CHAHAL SEMI TRUCK/TRAILER REPAIR FACILITY

6100 SCHOONER DRIVE
VAN BUREN TOWNSHIP, WAYNE COUNTY, MICHIGAN

Re: 6100 Schooner Drive
Van Buren Township, MI
Chahal trucking Facility

OHM review #1 response letter:

TOPOGRAPHIC SURVEY

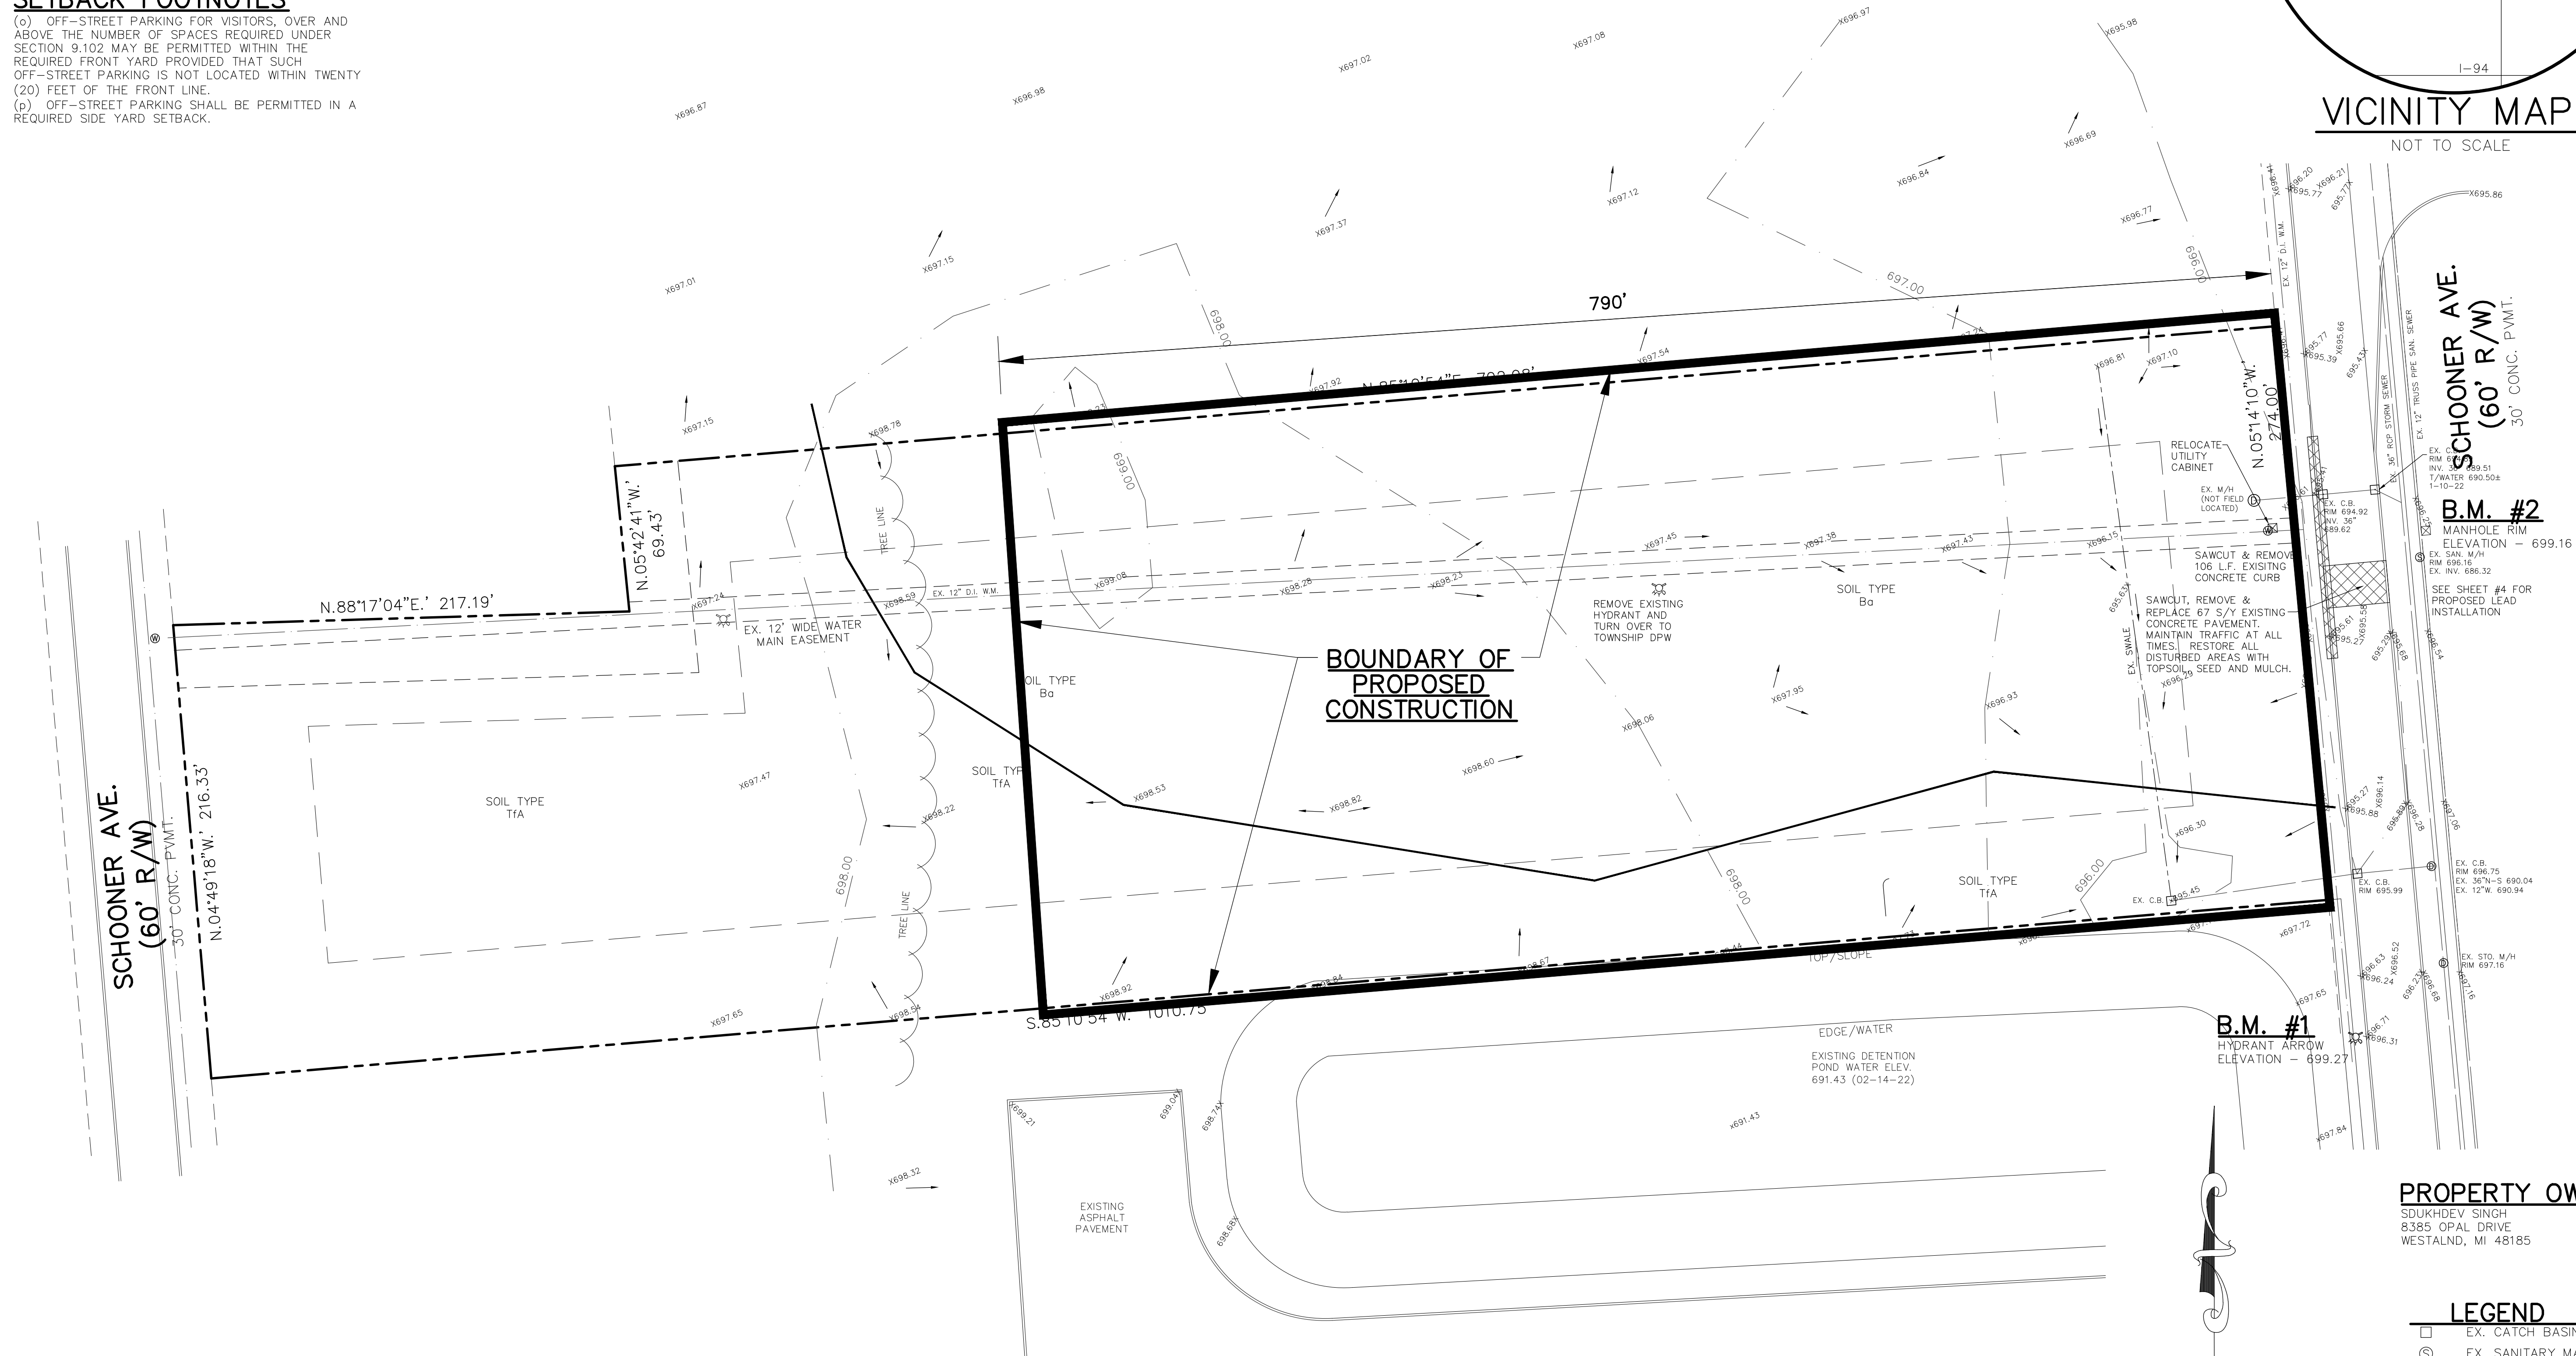
1. Noted
2. Land Use Summary added to cover sheet.
3. Existing utility information added to all appropriate sheets.
4. Water elevation within the existing pipe has been added to sheets #2, #3, and #4.
5. Storm sewer calculations for structures E to D added to storm sewer design chart.
6. Buffer strip has been dimensioned.
7. CPVC requirement has and is located withing the storm sewer design calculations on sheet #4
8. Forebay and Detention details have been revised.
9. Rainfall intensity has been revised.
10. All storm sewer lengths have been verified.
11. Storm sewer calculations have been revised.
12. HGL have been added to the profiles.
13. There is no pump proposed for this site.
14. Exhibits submitted on 8.5"x11" sheets.
15. Noted.
16. Noted.
